MILITARY SPECIFICATION

ARRESTING HOOK INSTALLATIONS, AIRCRAFT

This amendment forms a part of Military Specification MIL-A-18717B(AS), dated 10 September 1979, and is approved for use by the Naval Air Systems Command, Department of the Navy and is available for use by all Departments and Agencies of the Department of Defense.

Figure 1. Typical Arrangement and Details of Arrested Landing Deck Area on CV Type Flight Deck

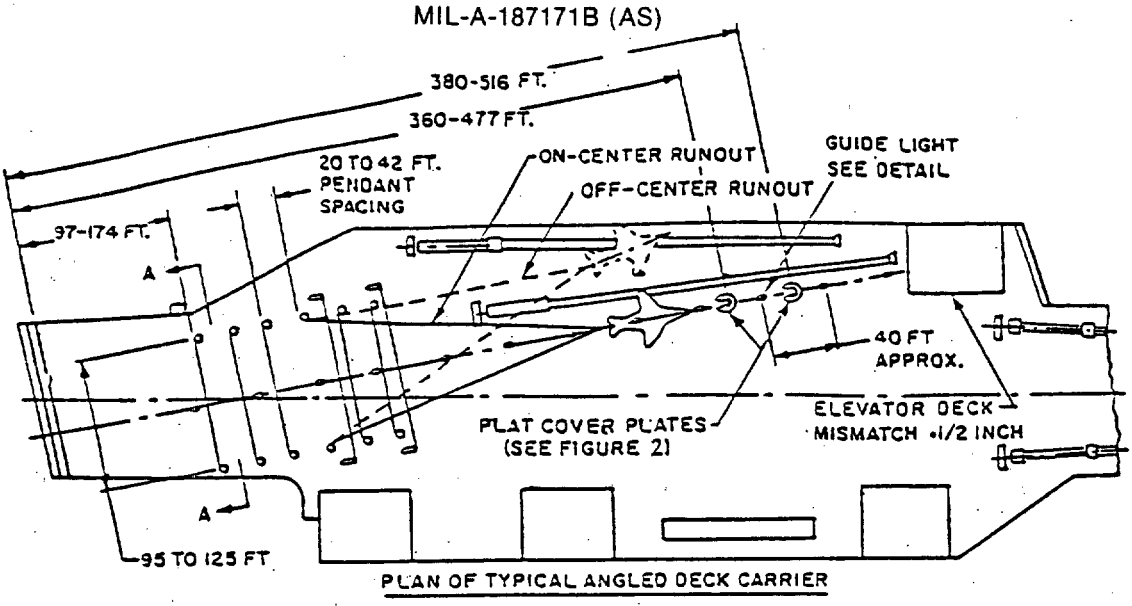
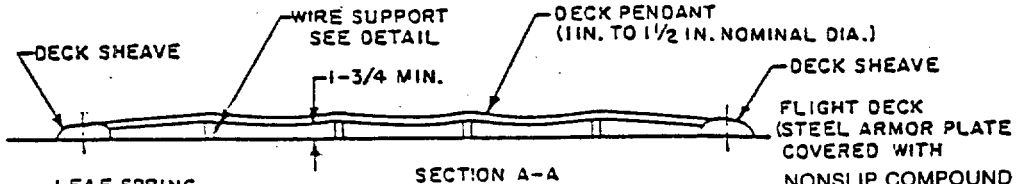
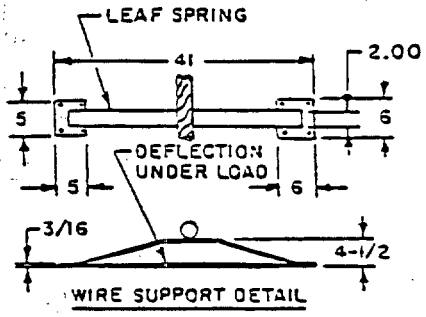
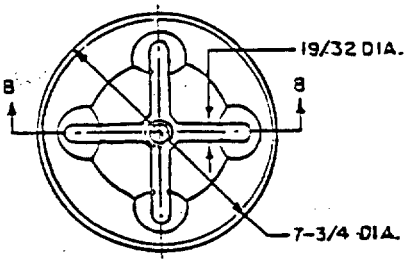
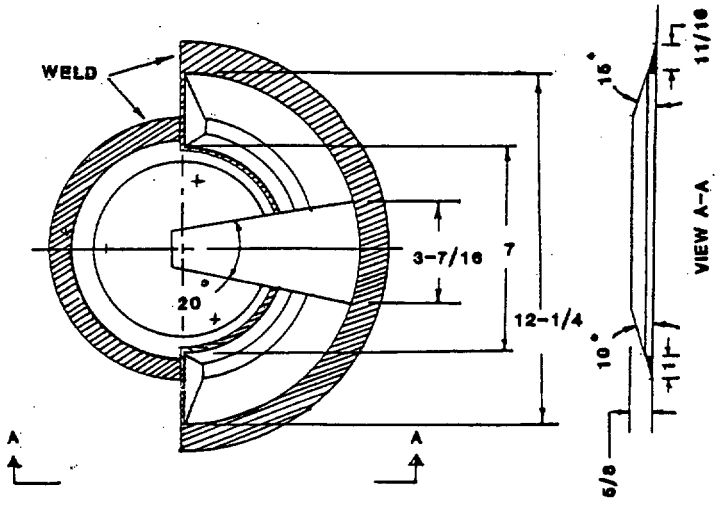
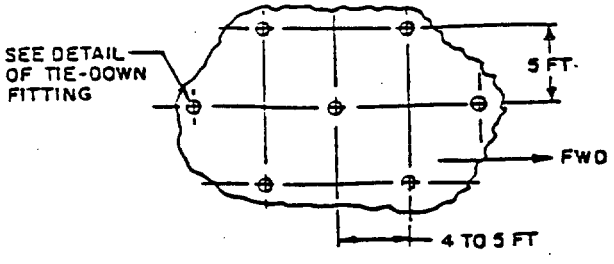
Delete entire Figure 1 and replace with revised Figure 1.

Figure 2. Pilot Landing Aid Television (PLAT) Installation

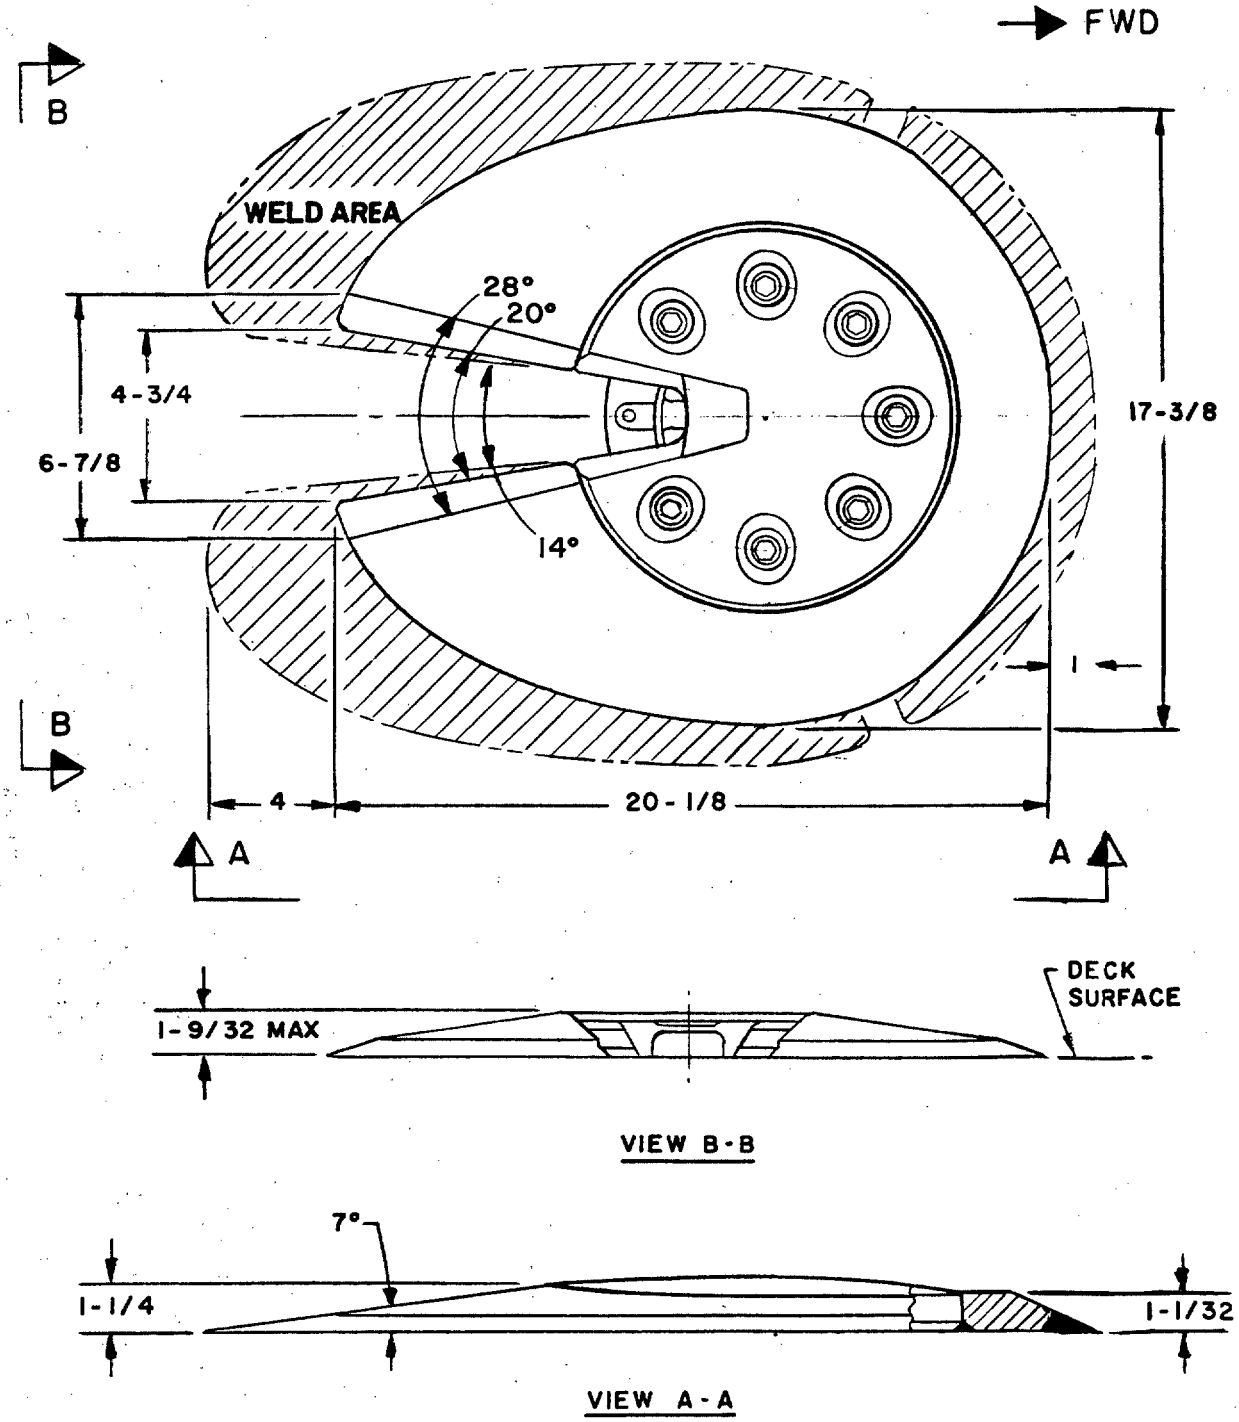
Delete entire Figure 2 and replace with revised Figure 2.

Revise Figure 2 title to read:

"Figure 2 Pilot Landing Aid Television (PLAT) Installation. . . . .5."
